Access Compliance Report

Public Rights-of-Way

Intersection ID: 4566	Main Street: LABORDE_AV	Cross Street: HOLLYWOOD_ST	Location: E
ADA ID: 3541C3F66798	Ramp Type: PerpDiag	Initial Pass/Fail: Fail	Overall Compliance: No
		Severity Score: 42.5

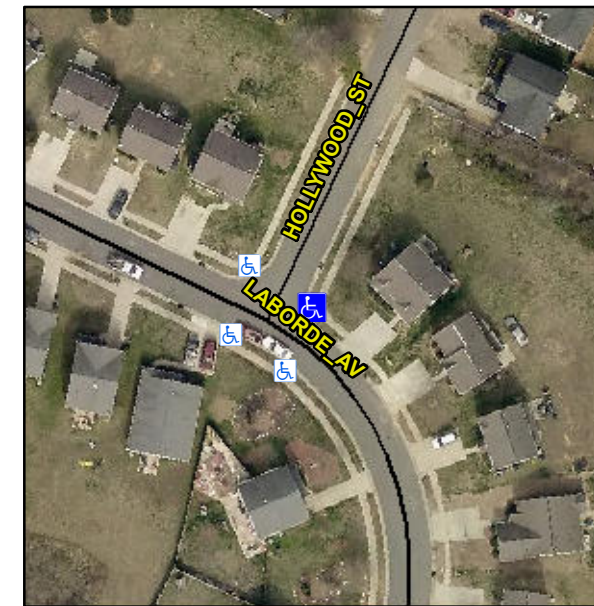
Not Found, R304.5.1, R304.2.2

Compliance	Description	Data	Compliance	Description	Data
N/A	Ramp Length (in)	46.5	No	Ramp Slope (%)	13.9
No	Ramp Width (in)	34.0	Yes	Ramp XSlope (%)	1.3
N/A	Flare Type LT	N/A	N/A	Flare Type RT	N/A
N/A	Flare Slope LT (%)	N/A	N/A	Flare Slope RT (%)	N/A
N/A	Flare Traversable LT?	N/A	N/A	Flare Traversable RT?	N/A
N/A	Landing Length (in)	N/A	N/A	DWS Provided?	N/A
N/A	Landing Width (in)	N/A	N/A	DWS Contrast?	N/A
N/A	Landing Slope (%)	N/A	N/A	DWS Length (in)	N/A
N/A	Landing X Slope (%)	N/A	N/A	DWS Full Width?	N/A
N/A	Landing Curb? (Y/N)	N/A	N/A	DWS Offset (in)	N/A
N/A	Shared Landing?	N/A			
N/A	Gutter Ponding?	N/A	N/A	Gutter Slope (%)	N/A
N/A	Gutter Lip Ht (in)	N/A	N/A	Gutter X Slope (%)	N/A
N/A	Painted X Walk1?	No	N/A	Painted X Walk2?	No
	X Walk 1 Direction	To NW		X Walk 2 Direction	To SW
N/A	X Walk 1 Width (in)	N/A	N/A	X Walk 2 Width (in)	N/A
	X Walk 1 Slope (%)	3.4		X Walk 2 Slope (%)	0.6
	X Walk 1 X Slope (%)	1.2		X Walk 2 X Slope (%)	3.3

Remove & Replace Curb Ramp With Two New Directional Ramps or Equivalent.
